ADDENDUM

Addendum Number:	03	Dated:	05/31/2024
Solicitation Number:	MR11493		
Solicitation Title:	Mother Neff State Park Headquarters (HQ) Renovation		
Due Date/Deadline:	June 11, 2024, at 2:00 PM		
Contract Manager:	Misty K. Wyatt, CTCD, CTCM

PURPOSE OF ADDENDUM: **Address Questions and Answers, Revisions to Bid Schedule and Drawings**

SHEET NUMBER
4
M2.0

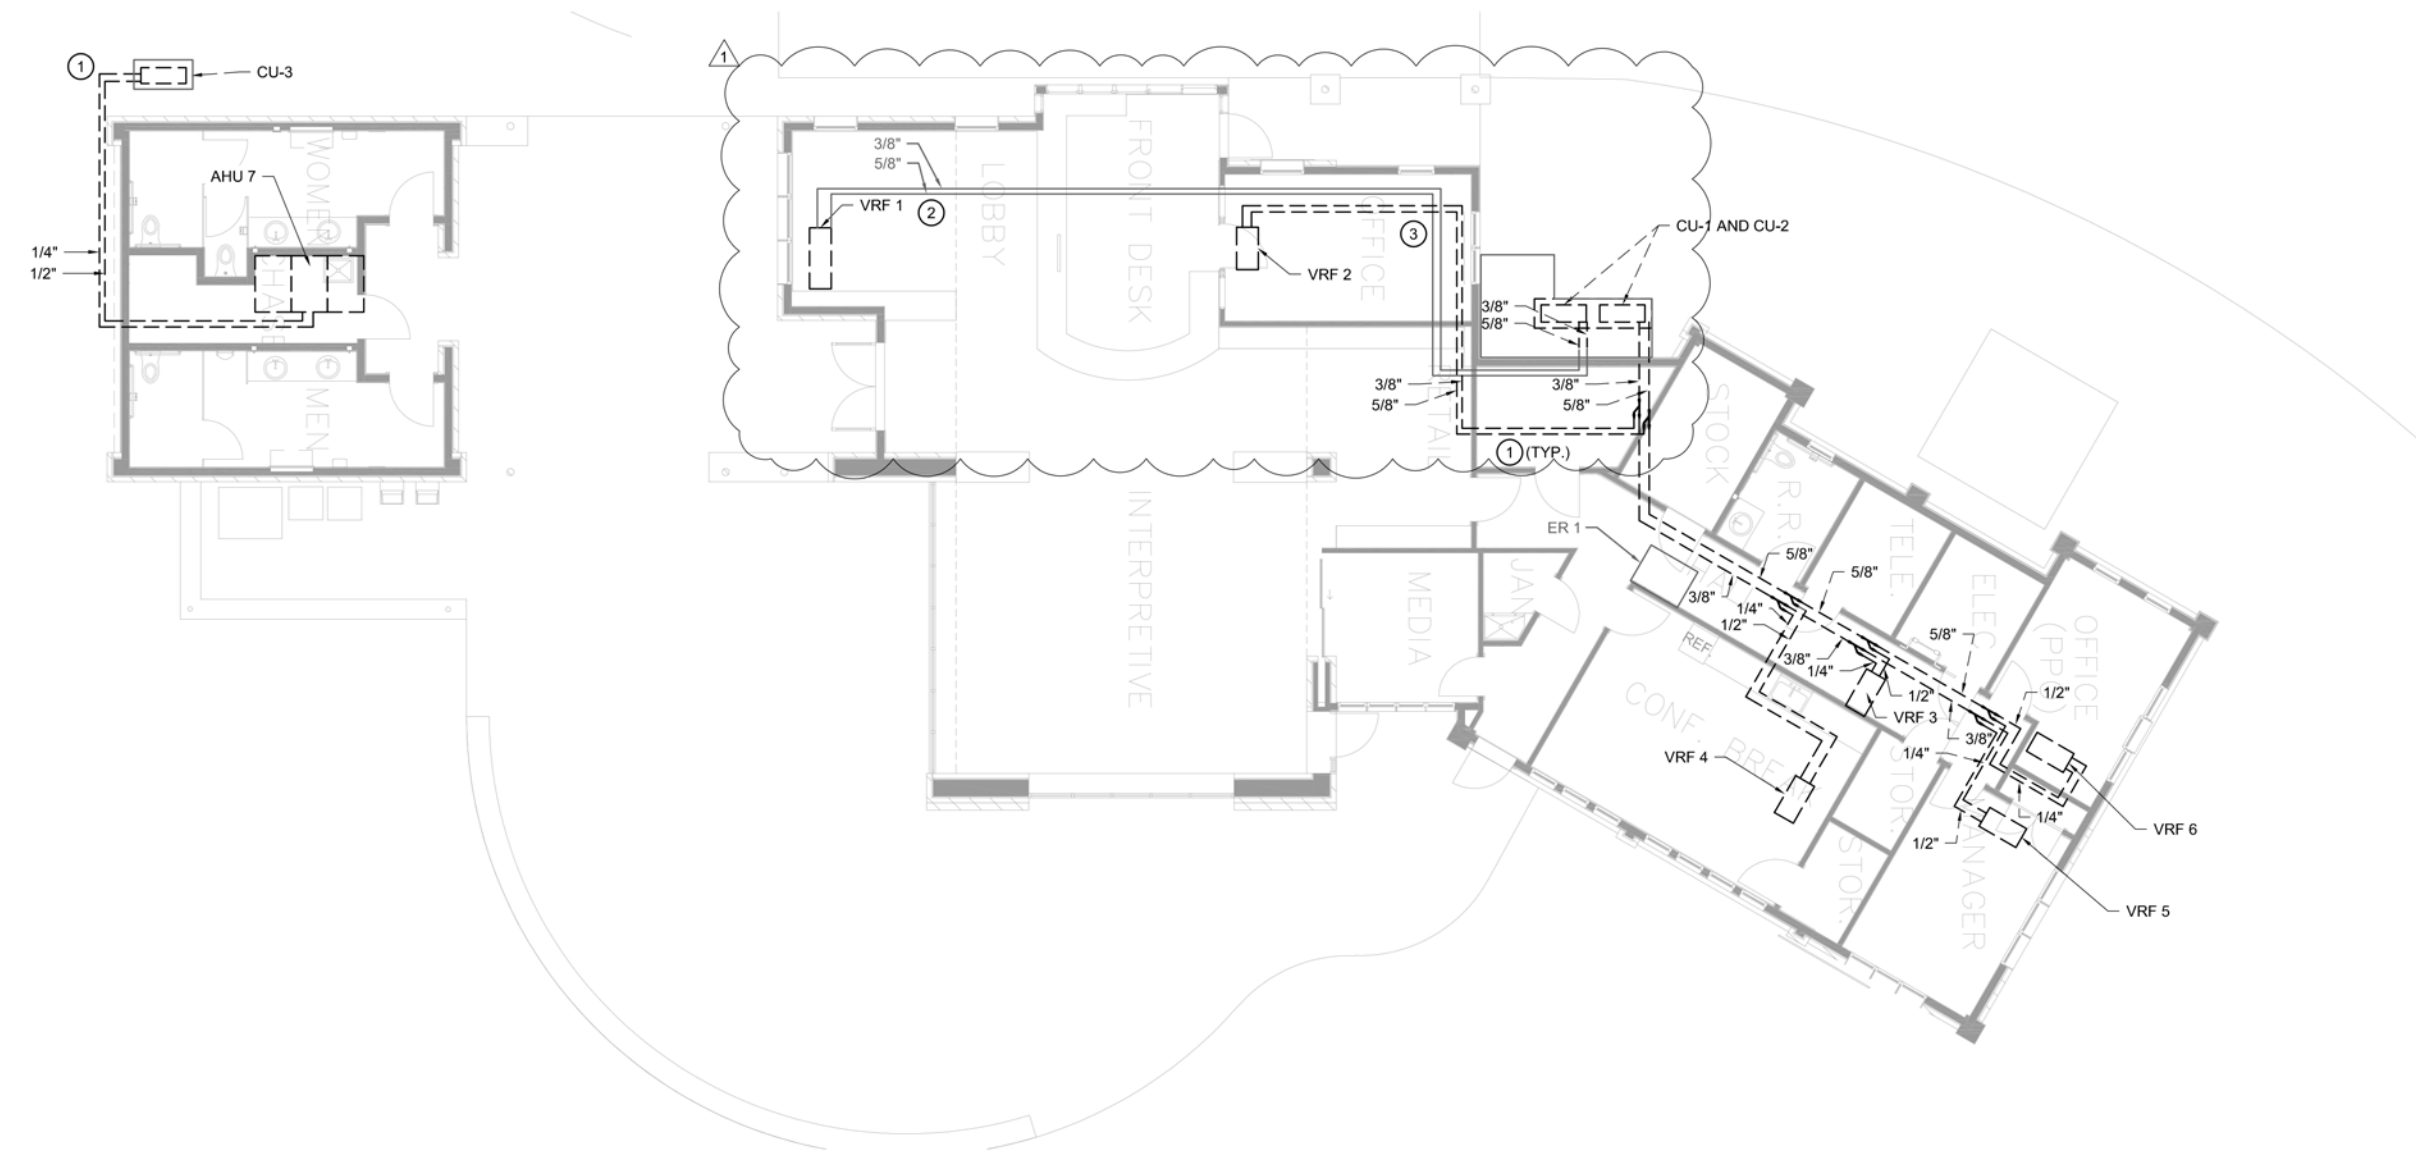
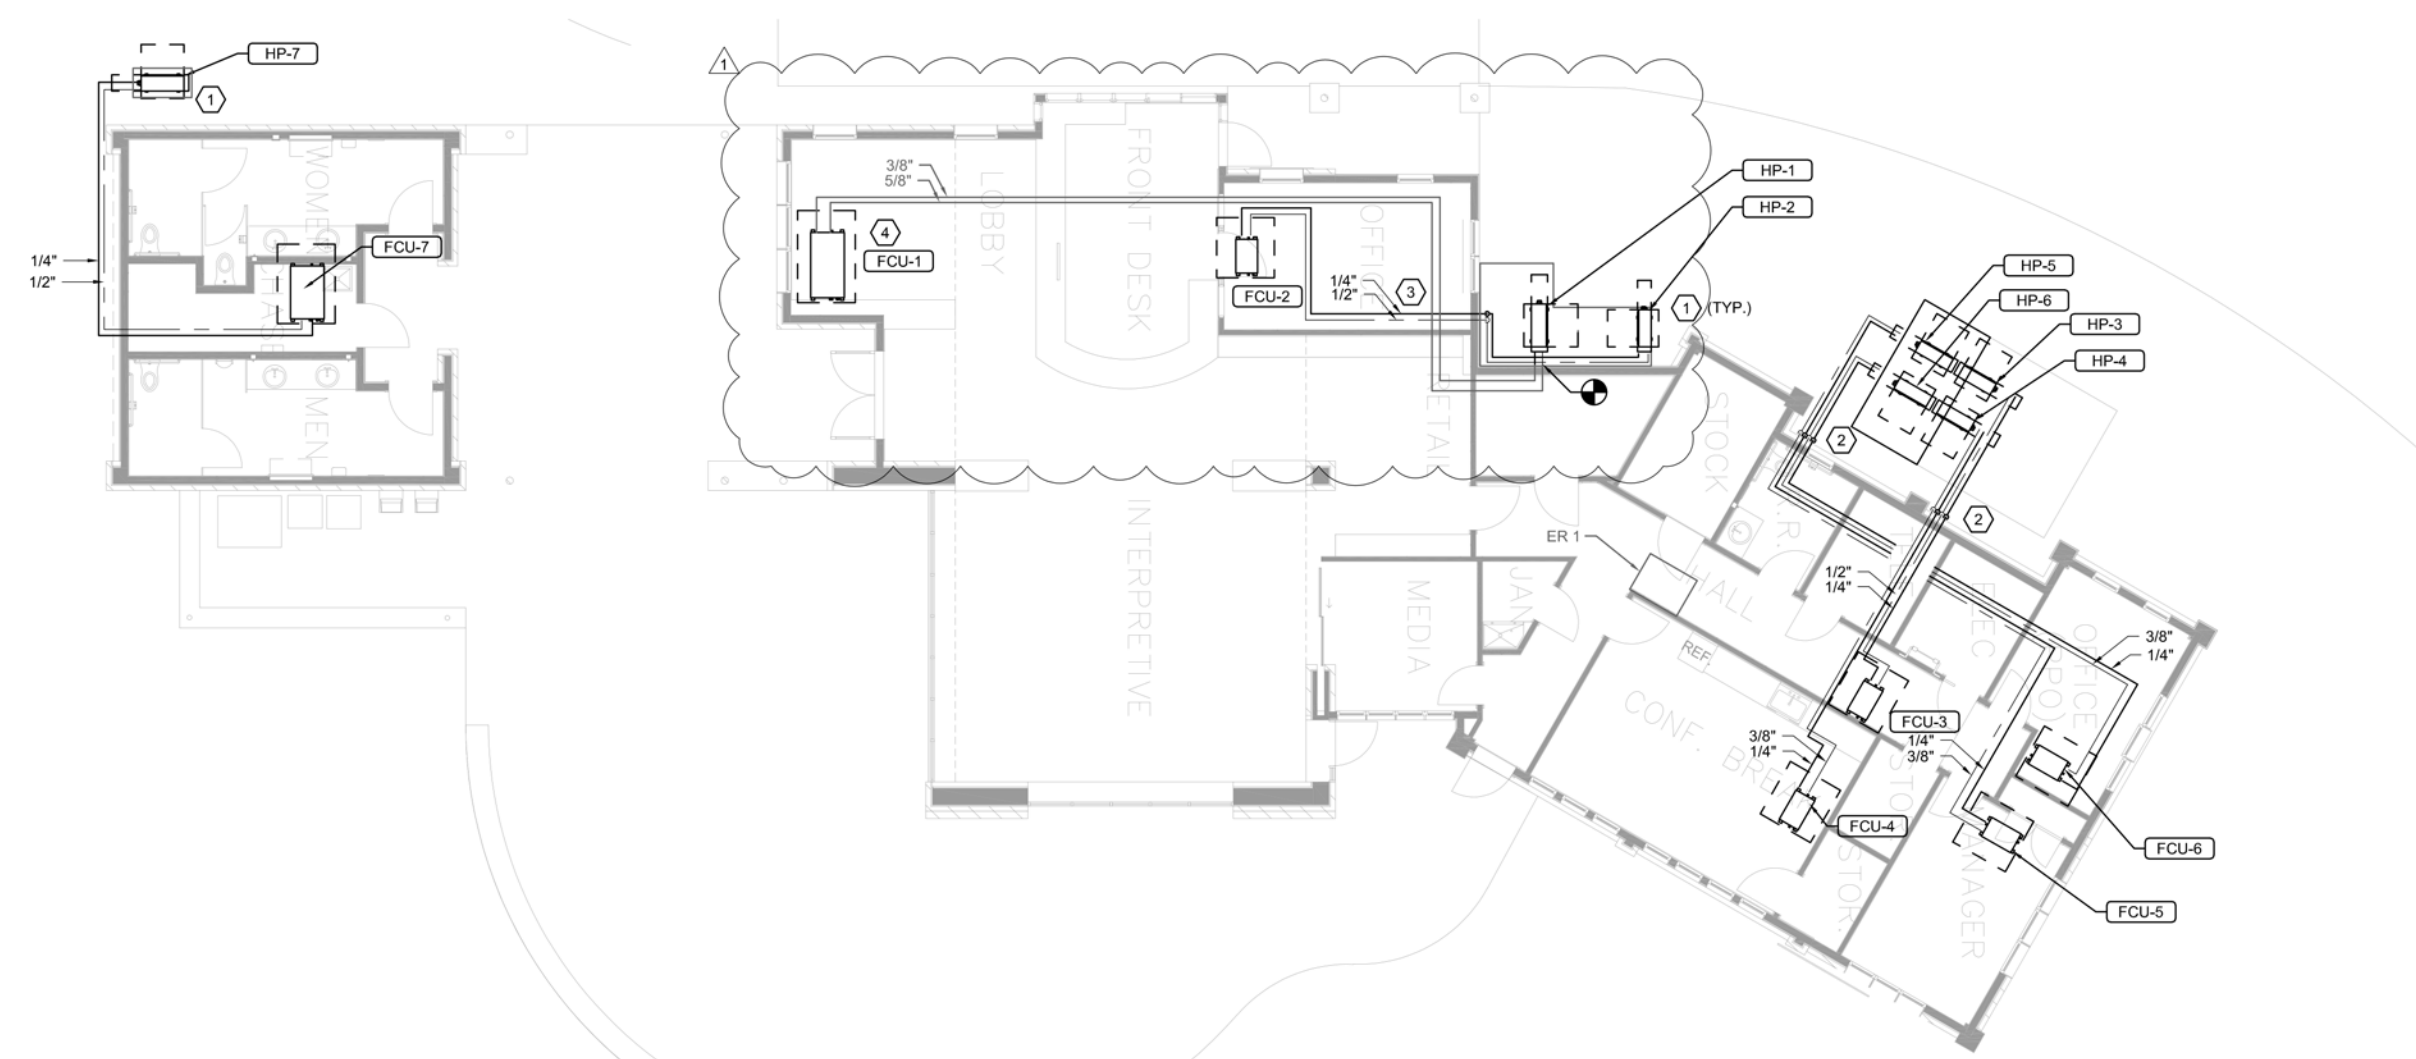
Q12: PLEASE ADVISE ON REPLACEMENT OF COPPER FOR SYSTEM 1 AND SYSTEM 2. NOTE, NO DIRECT PATH DUE TO FLAT ROOF.

A12: System 1 or FCU-1 piping shall be reused, reference Mechanical drawings. System 2 or FCU-2 will require new ACR copper piping due to different pipe size requirements. Refer to Keyed Note 3 on M2.0 for directions on routing.

1. DEMO EXISTING REFRIGERANT LINES AND BRANCH SELECTOR.
2. REFRIGERANT LINES SERVING FCU/CU-1 TO REMAIN AND BE REUSED.
3. DEMOLISH CEILING PER NEW WORK KEYED NOTE 3/M2.0 TO REMOVE LINES IN CEILING AREA.
